Project: 477 on MUSGRAVE-PHASE 1 & 2

Title: ELEVATIONS

Drawn:	CH/ JS	Checked:	KB
Date:	2023-08-08	Drawing Number: 6965-300	Revision:
Scale:	As indicated

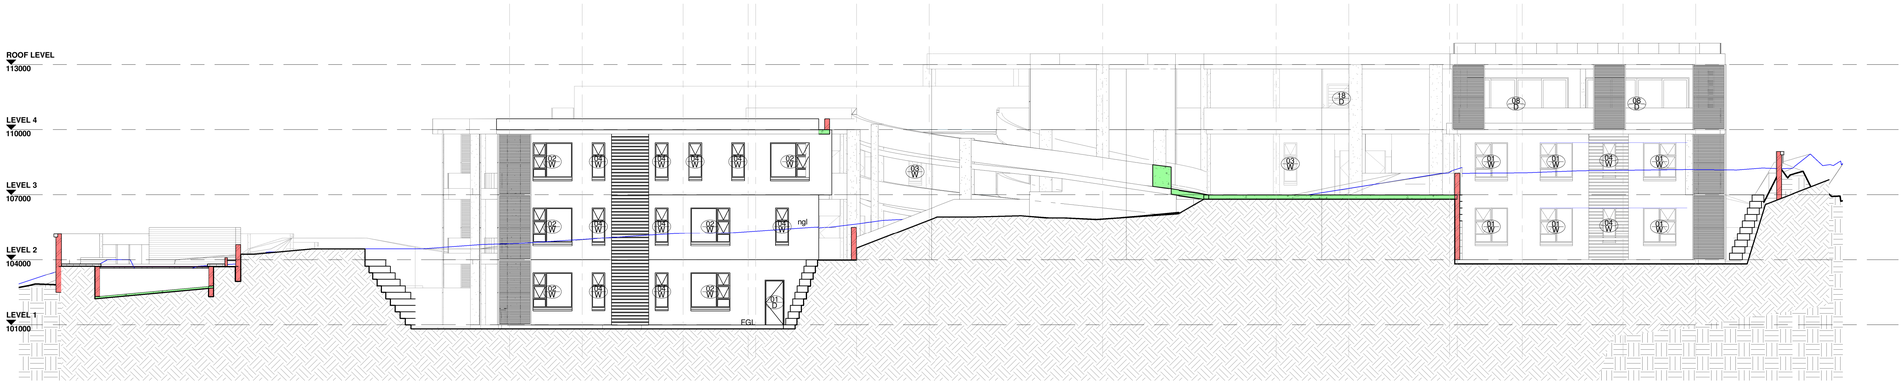
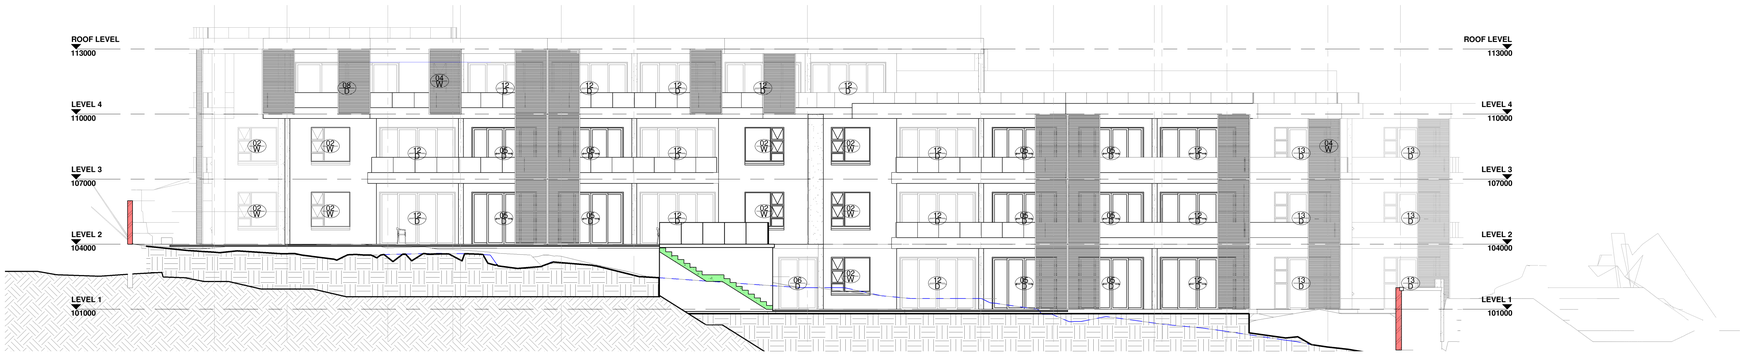
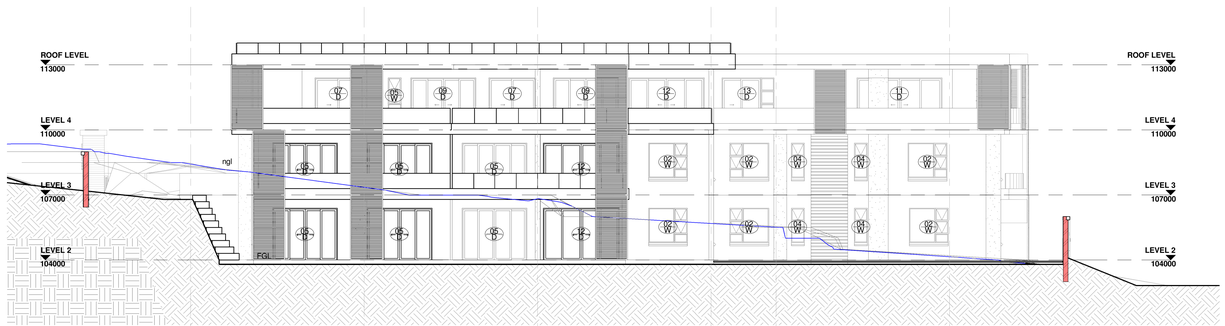
1.BALCONY EXTENTIONS REMOVED.
There is a Cape Dutch building on the adjacent site. The gable walls of the Cape Dutch building place emphasis on the vertical plane. We removed the balcony extensions to reduce the contrasting horizontal emphasis.

2. WINDOW PROPORTIONS RECONSIDERED.
W04 has been changed to a longer window, not only to create a more vertical puncture but also to be in closer proportion to the Cape Dutch windows on the adjacent site.

3. TIMBER LOUVRES HAVE BEEN ADDED TO THE EXTERIOR FACADE.
These louvres place emphasis on the corners of the building. This strengthens the idea of the vertical plane having more exaggeration than the horizontal. Timber shutters are typical to both Cape Dutch and 'Berea' style buildings. Further to this, the louvres modulate the building which is also typical of 'Berea' style.
